CONSOLIDATED EDISON COMPANY OF NEW YORK, INC.

Indian Point Station, Unit No. 2

Docket 50-247

Applicant's Responses to Round Two Questions
Submitted by the Citizens' Committee for the
Protection of the Environment (Set H)
on March 9, 1971

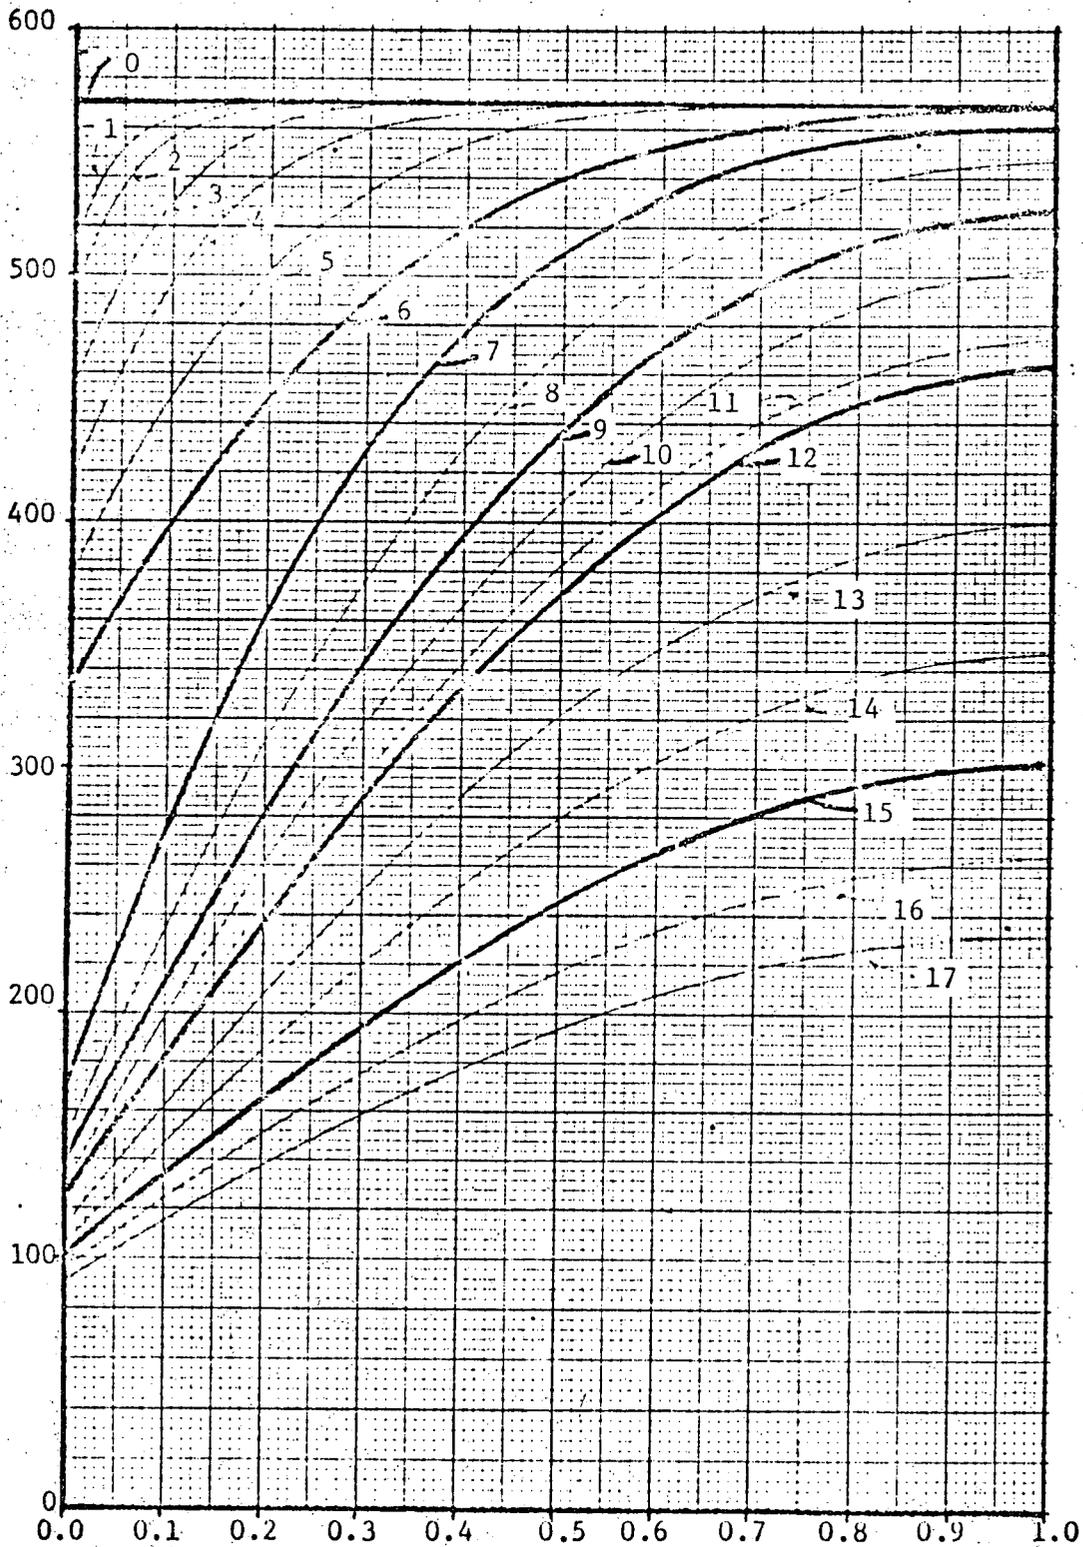
Question: Explain in detail the manner in which the following factors taken together and separately can affect the growth of flaws (indications, defects) in the reactor vessel including its welds and the primary piping system (if there is no effect, justify the conclusion; if there is, in your opinion, an insignificant effect, justify the conclusion regarding the extent of the effect and the insignificance of the effect).

- 5) all other relevant factors which will demonstrate the maximum possible stress at the weakest, possible point; and
- 6) answer the question with respect to the simultaneous impact of cooling water on the exterior of the reactor vessel as a result of the pipe break and the containment spray.

The analysis described in answer to Question D-50 is the appropriate analysis for the evaluation of the effects of cooling the reactor vessel with emergency core cooling water.

Figure 1, attached, gives the temperature distributions through the vessel wall obtained by that analysis as a function of time after initiation of cooling.
